**RE: PA22-044 – Olympic Vista PRD – Technical Review 1**

Please refer to our responses below which address all review comments received from the City of Marysville on February 28th, 2023, regarding the Olympic Vista PRD application package. You will find the markup comments listed in the order that they were written followed by our response in *italics*.

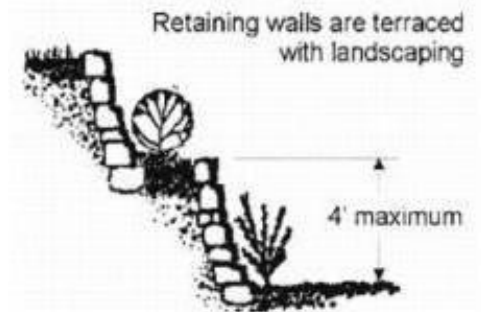
6. Pursuant to MMC 22D.050.030(4)(e), retaining walls taller than four feet shall be terraced so that no individual segment is taller than four feet. Compliance will be verified during civil construction plan review.

**Tall retaining walls must be terraced with landscaping as depicted below.**

**Response: Noted. There will be no walls facing the ROW that are greater than 4 ft that will require screening. Walls on the internal portion of the site will have a maximum height of 9 ft and will all face the private development and lots that will be purchased. Each homeowner will purchase the lot and home upon it with the understanding that they will have views that include that of a wall taller than 4'.**
